# Infill Housing Overlay Staff Comments & Recommendations

820 WATAUGA AVENUE LOT 25R - LINCOLN PARK RESUB. - BLOCK 5 PLAT 201912100039586 DIST: 7, WARD 18, CITY OF KNOXVILLE, KNOX COUNTY			OWNER/BUILDER - GARY KOONTZ SITE PLAN - JACOBS DIMENSIONS LLC		
JOB# 20200104	DRAWN: JJP	0129/2020	SCALE: 1" = 30'	BEARINGS AND DISTANCES ARE PER PLAT

**FLOOR PLAN**

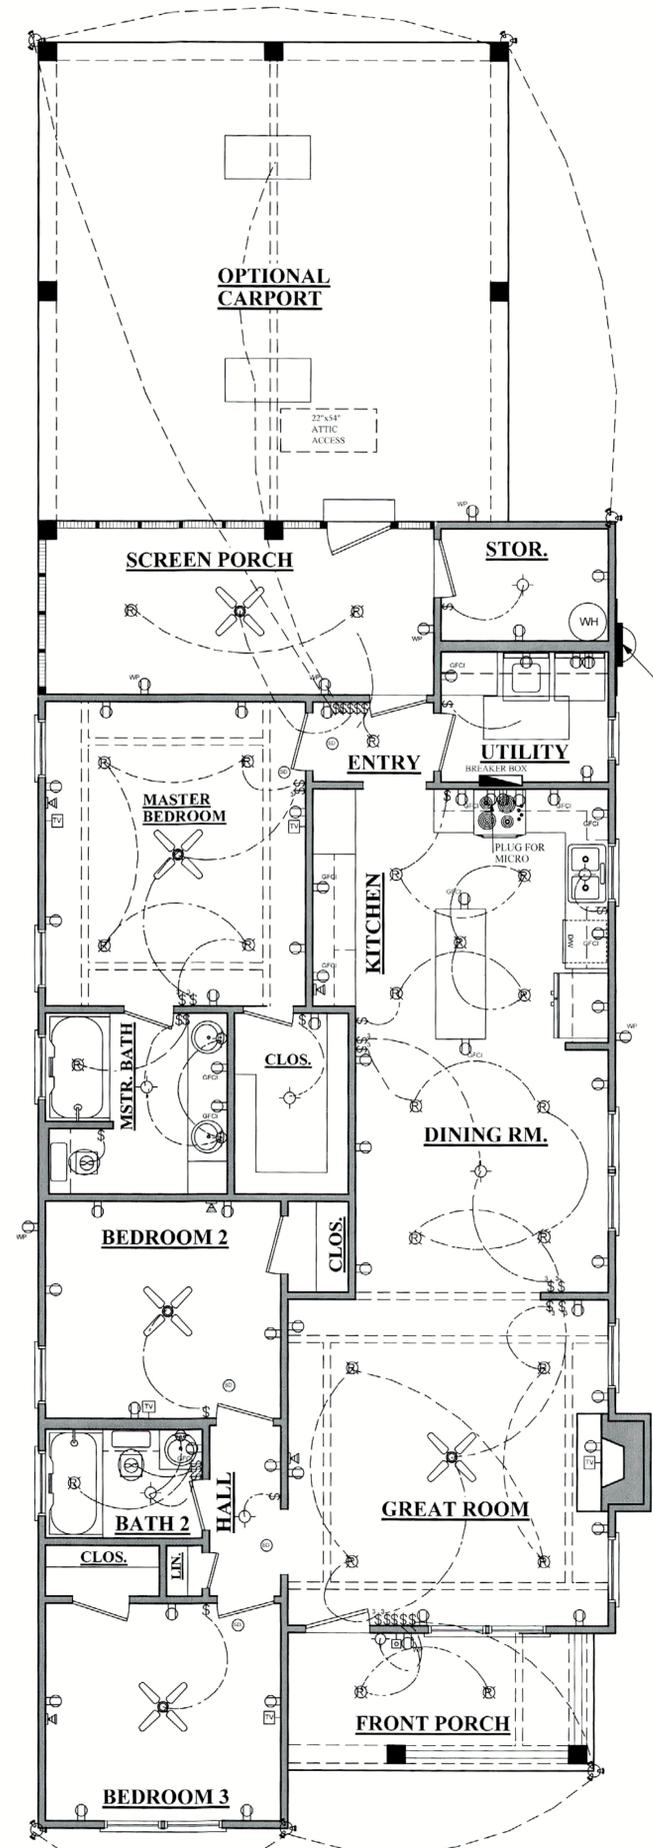
5. The proposed deletion of three windows on the left façade of the house creates a very high solid-to-void ratio. Retaining these windows allows more natural light to penetrate the interior and keeps the ratio more balanced.

7. The carport is noted as being optional in the building plans and would not be built.
8. The back porch would be open-air, not screened in as drawn.

6. Expand the porch depth to 8 ft. (p. 9).
7. Shingles should be a dark color (p. 12).
8. Retain windows on the left façade as shown on the elevations, not as shown on floor plan (p. 10).
